## STAFF REPORT

STAFF REPORT DATE: July 19, 2017

PROPOSAL: **Denney Road Commerce Center** (case files CU2017-0006, CU2017-0007 and DR2017-0040)

**Denney Road Commerce Center Site Plan**

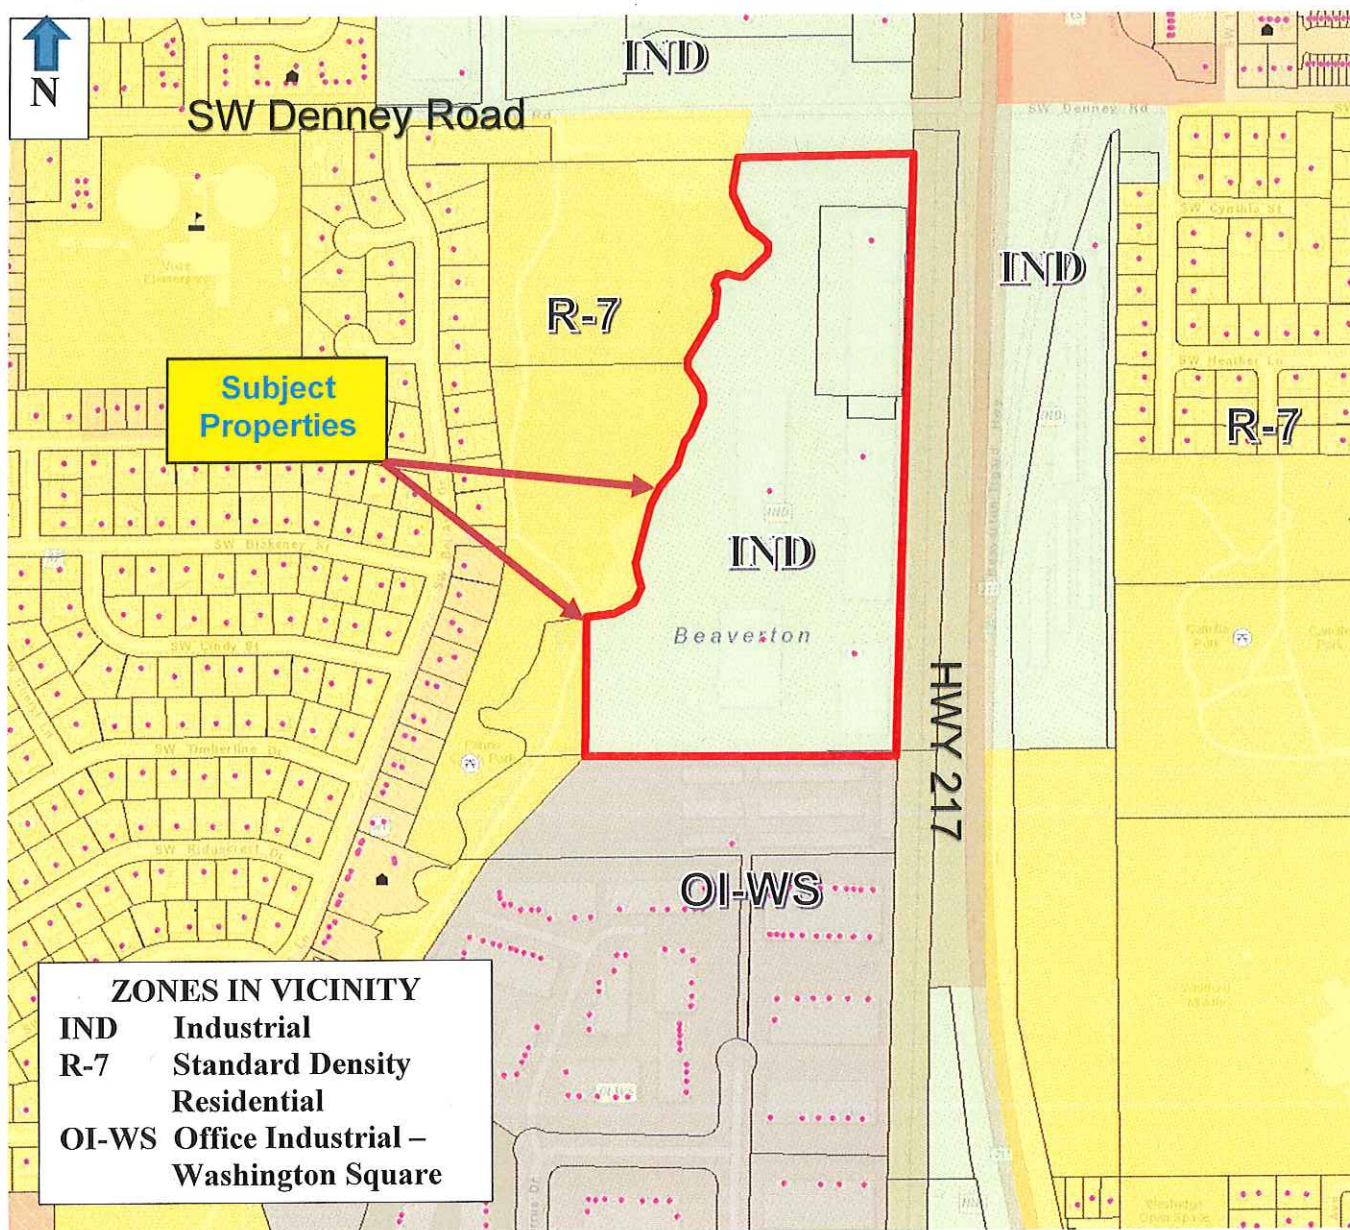
4. For CU 2017-0006 Vehicle Storage: Conditional Use approval acknowledges the need for adjusting the position of vehicle storage structures to avoid construction over an existing utility easement. These structures can be adjusted or modified within the same portion of the site.

20. Ensure storage structures are not shown to encroach the existing utility easement shown to cross the subject site. This condition does not preclude the ability to move the structures elsewhere on site provided the plan revision is shown to comply with necessary fire lane access. The plan for moving structures would be subject to review and approval by the Fire Marshal and Chief Building Official. (Site Development Div./JJD / Planning / SW)
